LINCOLN/LANCASTER COUNTY PLANNING STAFF REPORT

P.A.S.: Waiver #04011

PROPOSAL: Waive the width to depth ratio associated with Sunflower Addition final plat

SUNFLOWER ADDITION

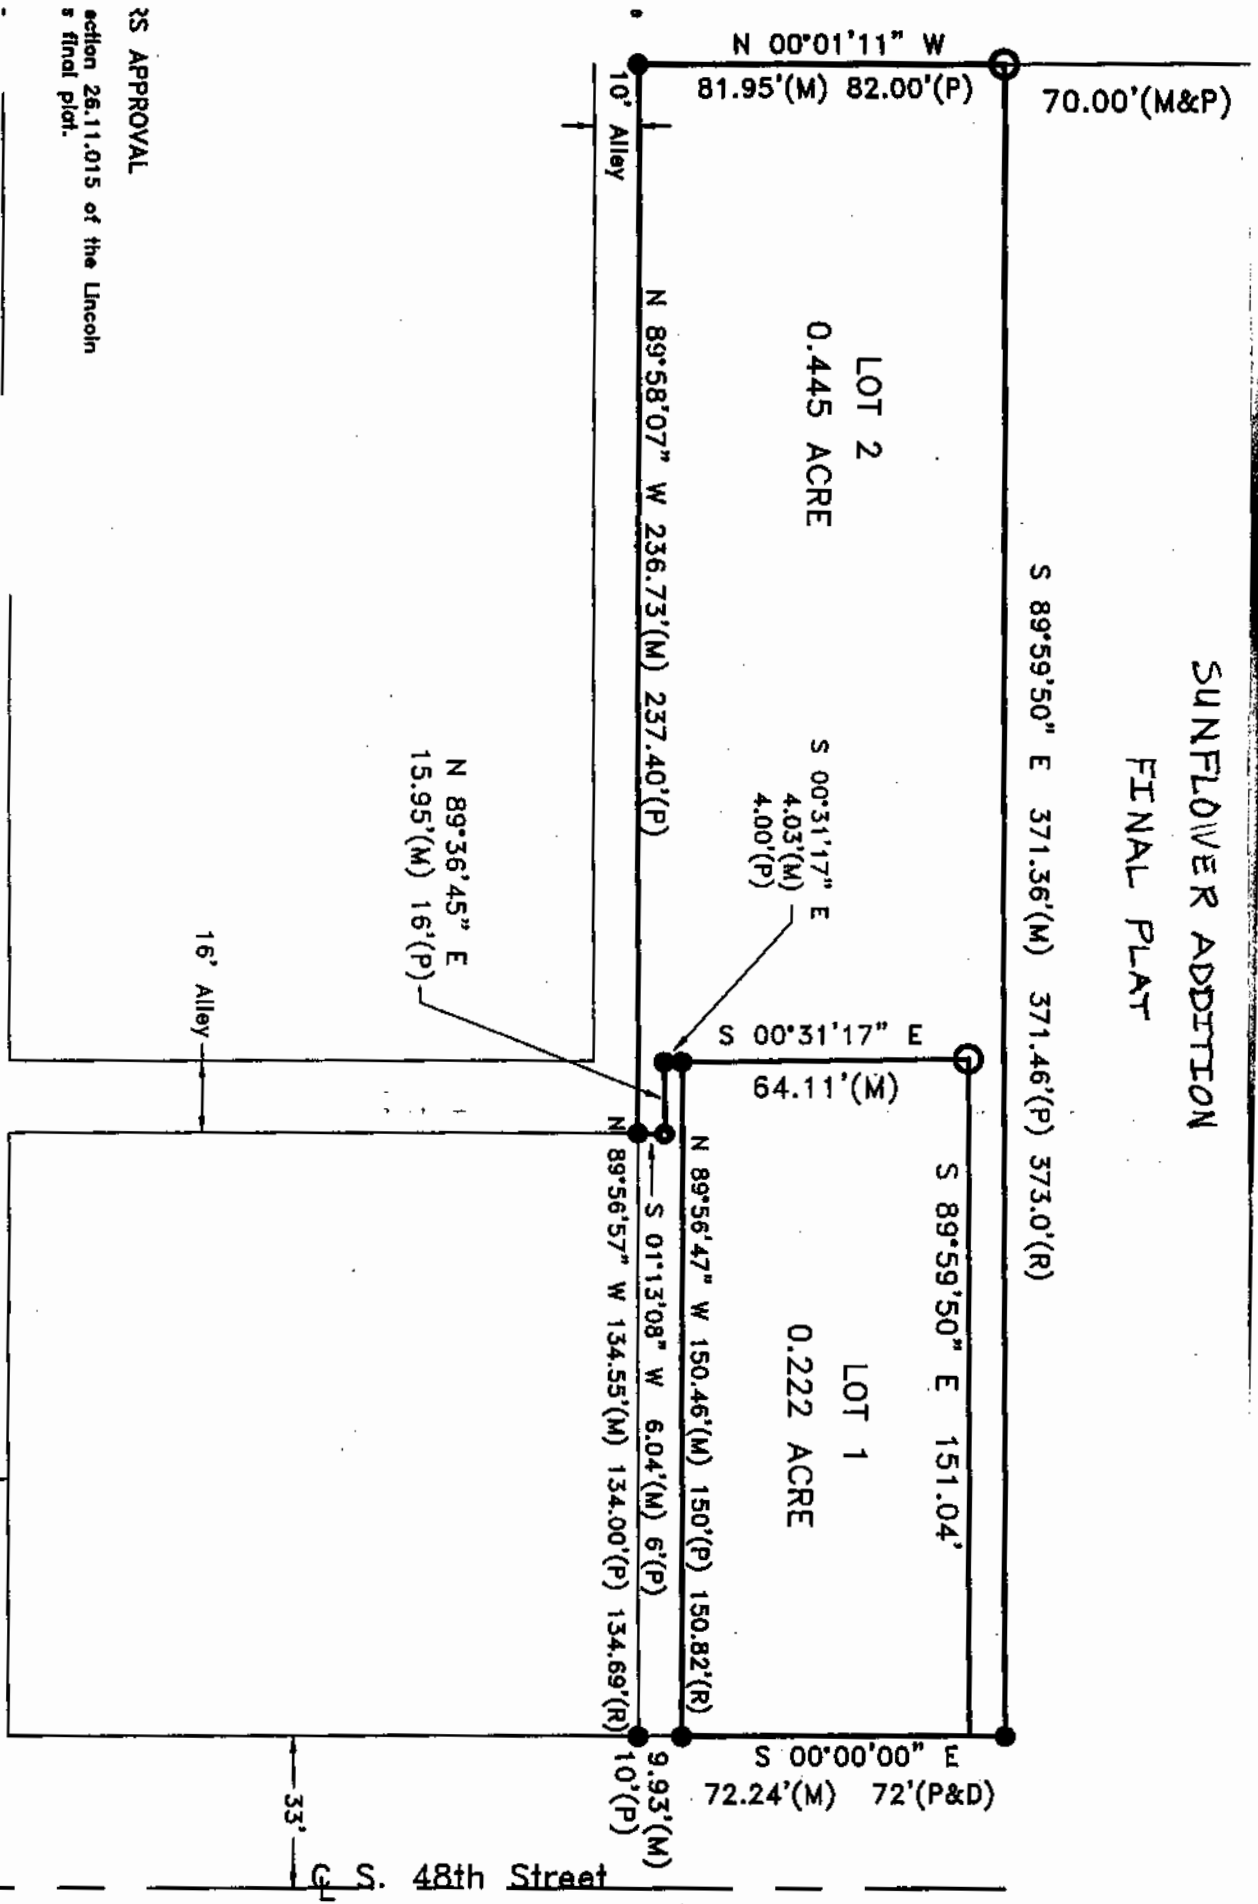
CONCLUSION: Although the Planning Department usually supports the subdivision of oversized lots, there must be adequate clearance for a proper size driveway on the flag lot. The narrow strip from S. 48th St. does not have adequate width for a proper size driveway.

1. This request is to waive Section 26.23.140 of the Land Subdivision ordinance requiring lots to have a maximum depth of three times its width.
2. The waiver request is associated with Sunflower Addition final plat.
3. Although the Comprehensive Plan promotes infill development, the driveway must be of adequate size to meet design standards.
4. The lot has 72' of frontage and is 371' deep. The exceptional depth of the lot allows for an additional lot in the rear. This can only be accomplished by designing a flag lot that has a depth of more than three times its width.
5. That portion of Lot 2, that provides access to S. 48th St., is only 8 feet wide and has an existing driveway. This driveway allows access to the rear of the existing house for two dwelling units. A two-family dwelling would be allowed on Lot 2. This narrow driveway would have to support traffic for four dwelling units.

6. The City of Lincoln Design Standards requires driveways for multiple dwellings to be a minimum of 15 feet in width. The existing driveway does not meet this standard.
7. Although the Planning Department supports the subdivision of oversized lots, the lot must have adequate clearance for a proper size driveway.
8. Public Works & Utilities Department recommends denial of this waiver due to the inadequate width for access to South 48th St.
9. The existing house has three dwelling units which appears to have been converted from a single-family house without building permits or zoning approval.
10. This area would be better served if several property owners would cooperate to redevelop the area into urban sized lots.

The City Engineer's Office of the Department of Public Works and Utilities recommends denial of the requested waiver for the width to depth ratio of the R-2 Lot at 3405 South 48th Street.

The final plat does not allow adequate width for access from South 48th Street.

The comments on the final plat report need to be addressed prior to consideration of waivers.
